MONTGOMERY COUNTY HISTORIC PRESERVATION COMMISSION
STAFF REPORT

Address:	3 Hesketh Street, Chevy Chase	Meeting Date:	9/4/2024
Resource:	Contributing Resource Chevy Chase Village Historic District	Report Date:	8/28/2024
Applicant:	Lars Jeurling (Venture Solar, Agent)	Public Notice:	8/21/2024
Review:	Historic Area Work Permit	Tax Credit:	n/a
Case Number:	1074417	Staff:	Laura DiPasquale
Proposal:	Solar Panel Installation

STAFF RECOMMENDATION

Figure 4: The roof plan (left) shows the proposed panel and equipment locations, and the site plan (right) shows the orientation of the house to the larger property.

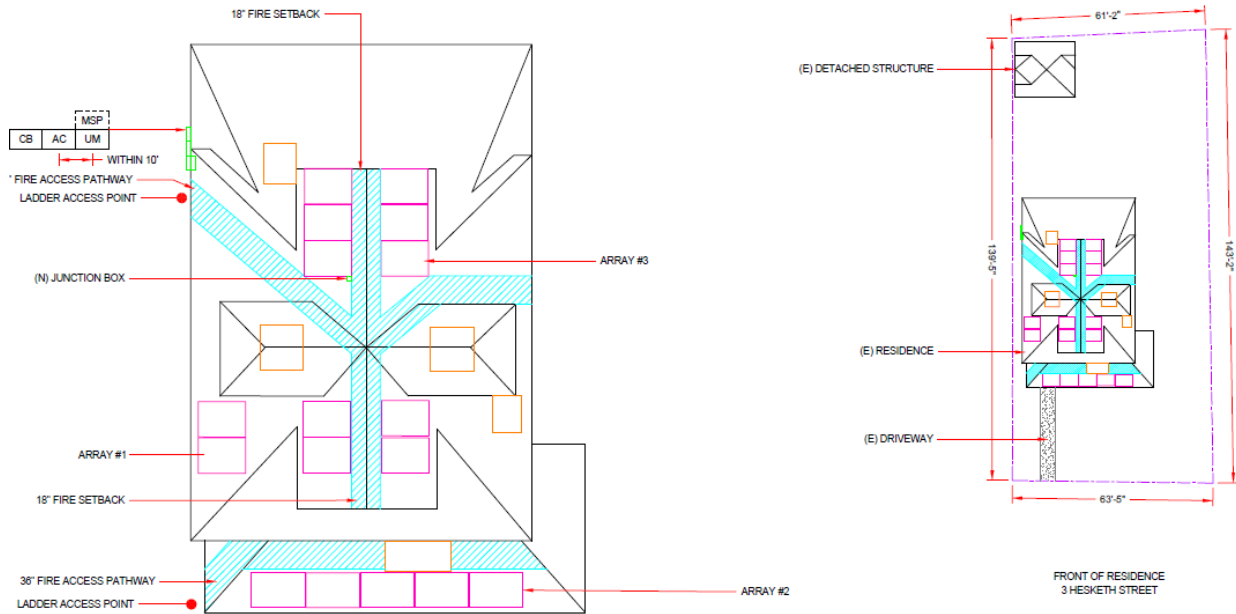
The applicant proposes to install 17 roof-mounted solar panels: five panels across the front porch roof, two panels on each side of the front gabled dormer roof, two on the left (west) side hipped roof, and three on each side of the rear gabled dormer roof. The 17 HANWHA QCELLS: Q.TRON panels will be mounted to the asphalt shingle roof with SnapNrack mounts and will cover a total of 357.33 square feet of the 2,230.79 square foot roof (Figure 5). The associated junction, solar inverter and disconnect boxes will be located towards the rear of the west elevation adjacent to existing utility panels (Figure 4).

The written scope of work also includes “Rip & Reroof” but no further details are provided. The existing roof is clad in 3-tab asphalt shingles. Staff could approve a HAWP for replacement of the shingles with new architectural shingles.

Figure 6: Shade map for 3 Hesketh Street.

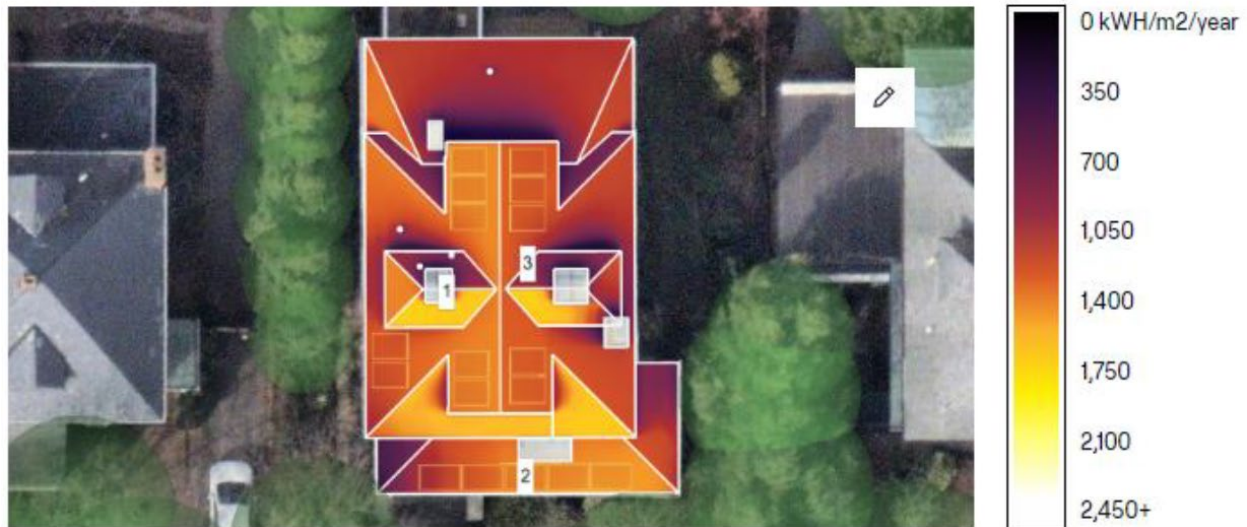
house, respectively. The rear roof slope of the subject house is north-facing, and the shade map shows limited annual irradiance in this area (Figure 6), leaving the original roof as the only feasible location for the installation of solar arrays. The submission materials indicate that the front panels are necessary to produce sufficient electricity to meet the home's need and ensure the project's financial viability.
